**RE: Maverik – Gibson
Grading & Drainage Plans
Engineer's Stamp Date: 12/22/23
Hydrology File: M15D021D**

RE: Plan Review – Maverik Yale & Gibson - Plan Review Comment Responses

MAVERIK STORE
2121 YALE BLVD SE
ALBUQUERQUE, NEW MEXICO
GRADING PLAN

MAVERIK
ALBUQUERQUE, NEW MEXICO
MAVERIK STORE
2121 YALE BLVD SE
ALBUQUERQUE, NEW MEXICO
DRAINAGE PLAN

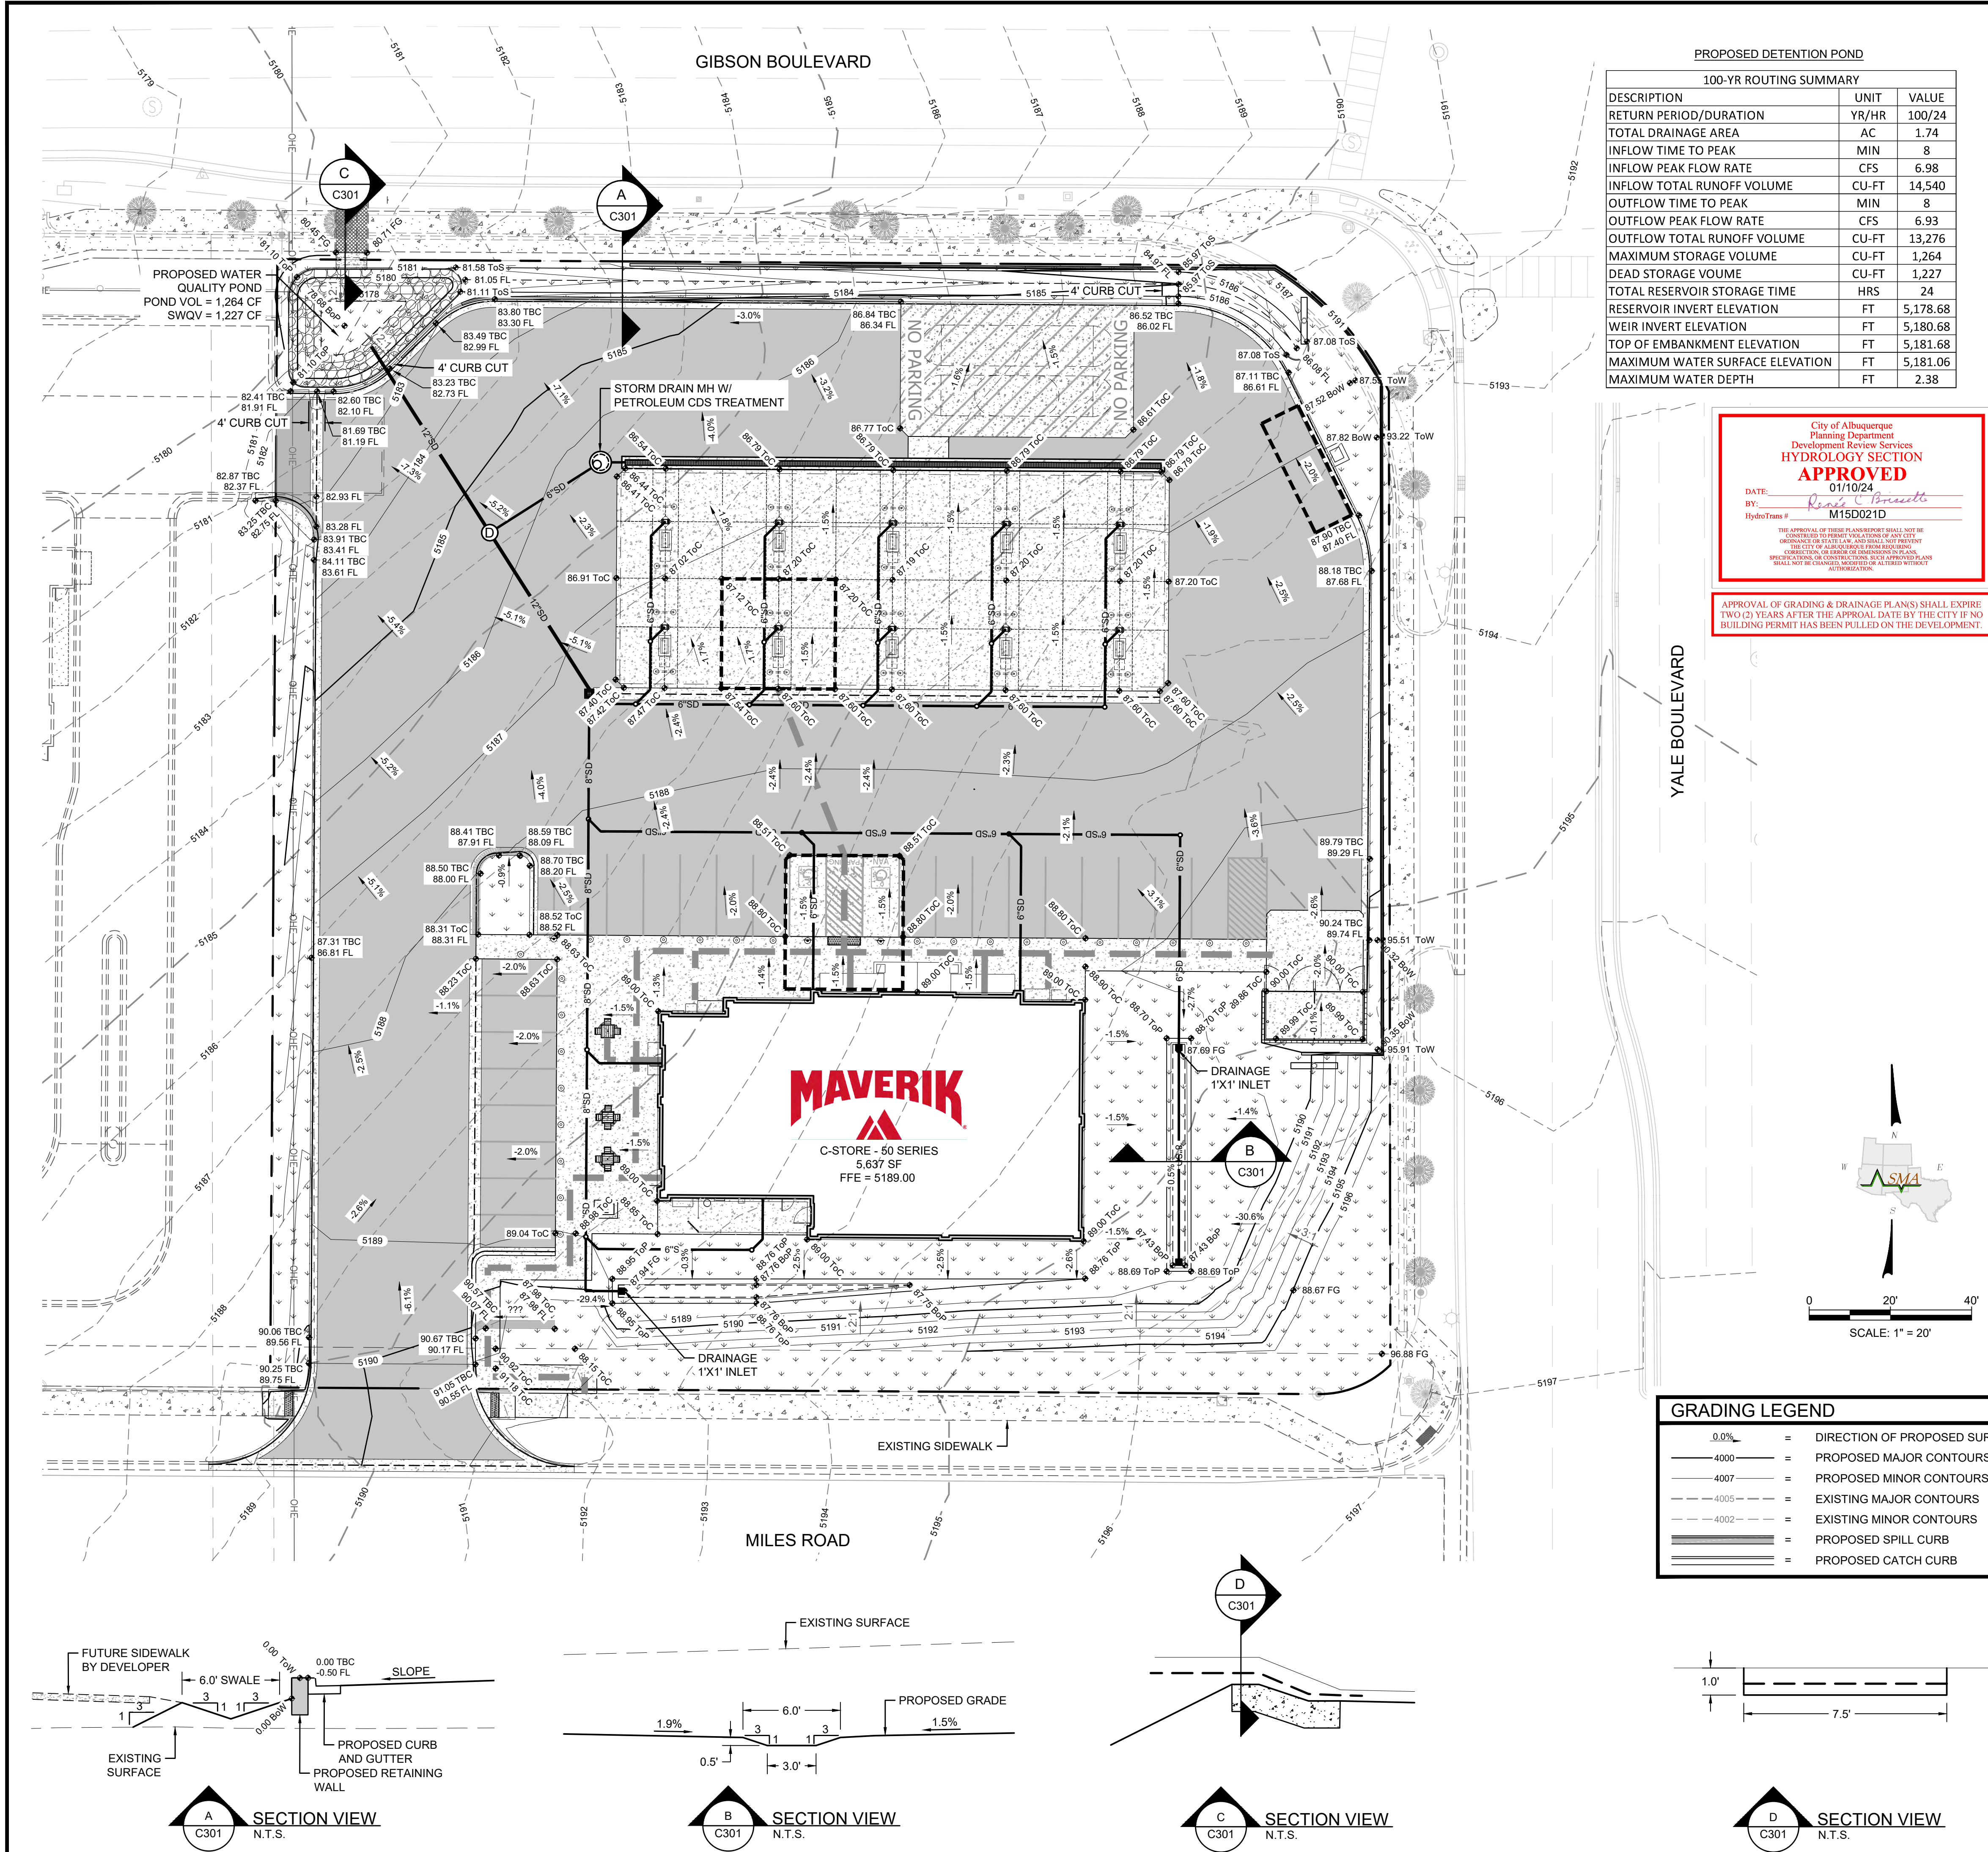
1. *There appears to be a layer turned off for the existing curb & gutter within Gibson & Yale.*
a. Layers for the existing site have been turned on or unfrozen.
2. *All gas stations must drain to an oil/water separator (the Owner's choice) prior to discharge. This appears to drain into a manhole prior to going into the stormwater quality pond. Please label this manhole as an oil/separator.*
a. Point labels have been rotated to show the CDS manhole and has been labeled.
3. *Please use the latest SO-19 Notes (Attached).*
a. Light pole design has not been provided.
4. *Label "PROPOSED SIDEWALK CULVERT 7.5' X 17", to be modified as Existing.*
a. Label has been changed from Proposed to Existing.
5. *Plans need to be stamped with a full date (month\day\year, this is how they reference it).*
a. Plans have been stamped and dated as requested.
